SERVICE BULLETIN

NUMBER: 12-312-21
DATE: 02/19/21

SUBJECT: Center Console Armrest Cover-
 Wrinkled Appearance

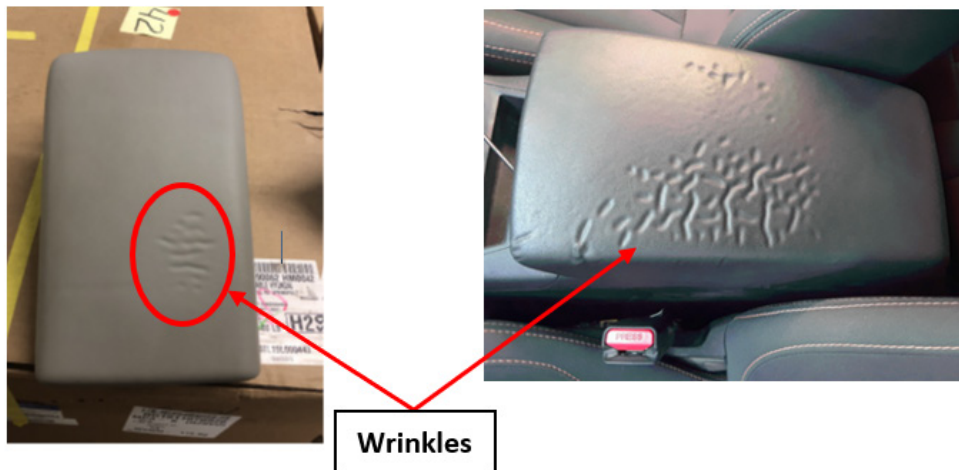
This bulletin announces availability of new center console armrest covers to address the wrinkling condition shown in the photos below. When the cover comes in contact with oily substances (e.g. some sunscreen products), the pictured condition may result over time. The new center console armrest covers are made with a material with higher durability and improved resistance to oily substances.

The new covers were incorporated into production starting with the following VINs:

- Impreza 4-Door: **M3600903**
- Impreza 5-Door: **M3701523**
- Crosstrek: **MH206323**
- Forester: **LH572688**
